## Certificate of Appropriateness

1851 N. 2ND ST.

PTS ID 114641 COA: Partial Roof & 1 window

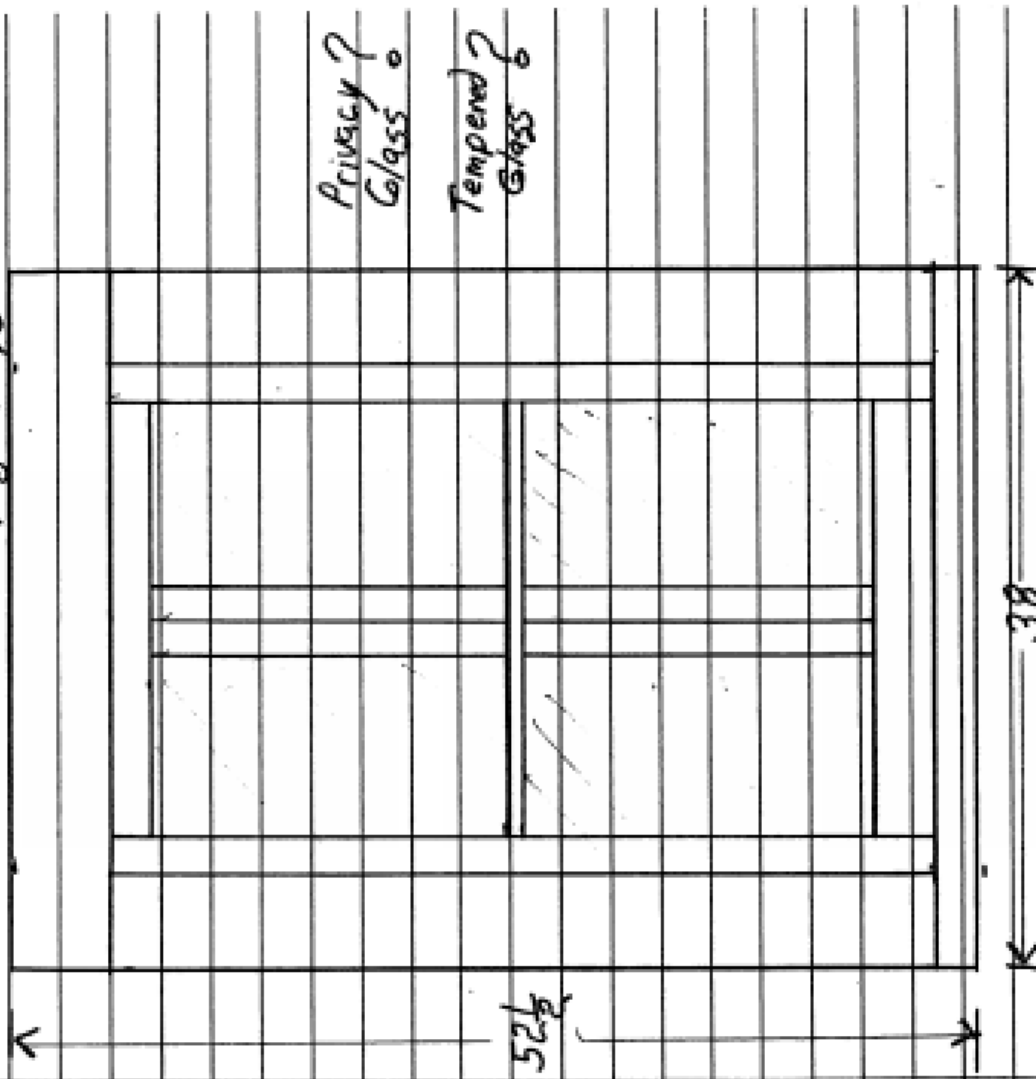
The door numbered 5, at right, will be replaced with the wood window shown on the following page. New trim shall match existing window trim on the house.

Safranek Residence 1st Floor Front Bath

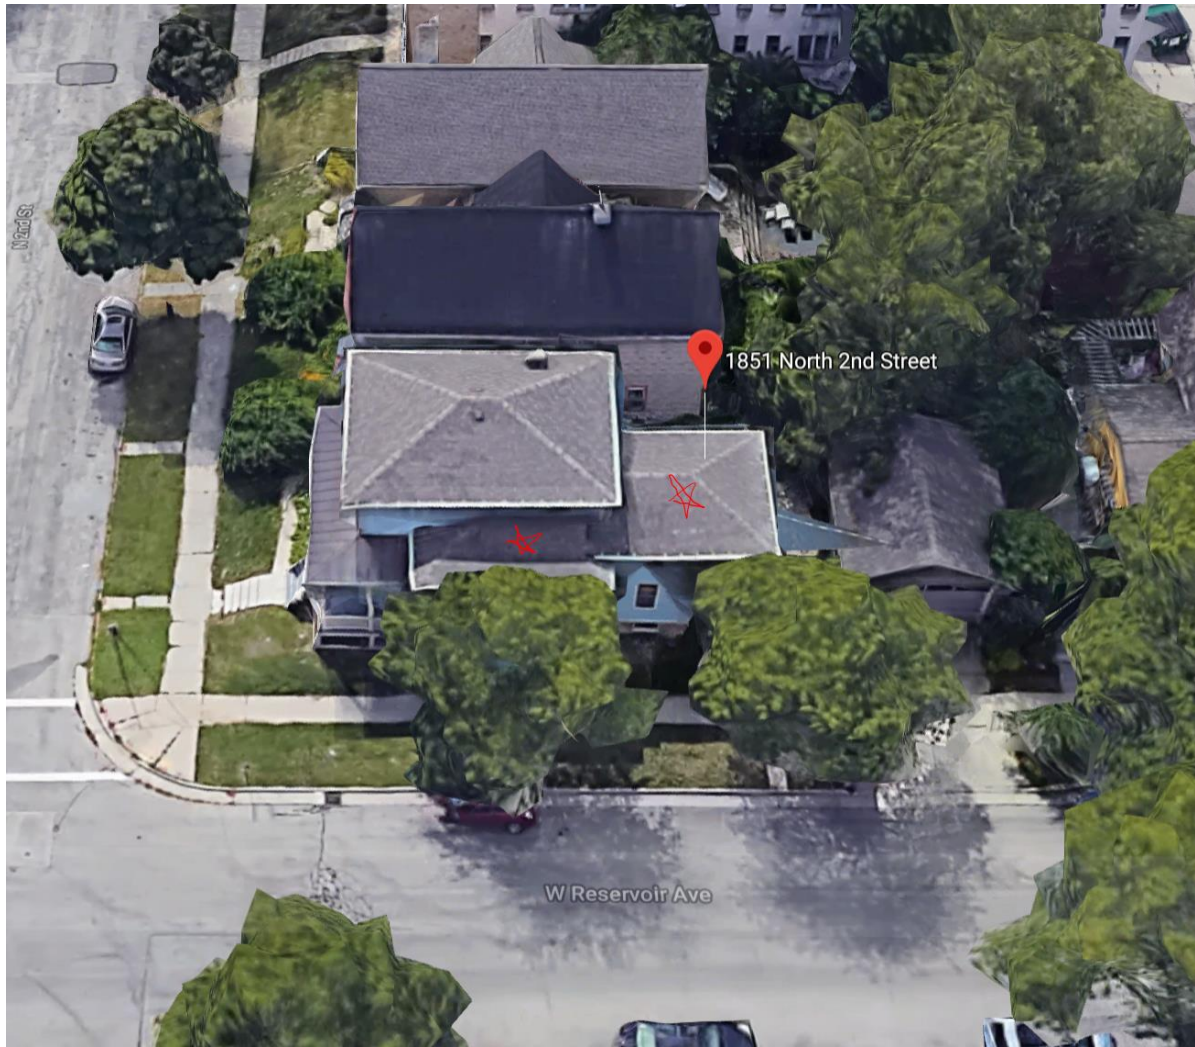
Privacy?  
Glass?

Tempered?  
Glass?

Drawn with 5" Casing to Match  
Front Elevation Windows (NOTE TO CONSIDER  
Casing width)

Window for front porch.
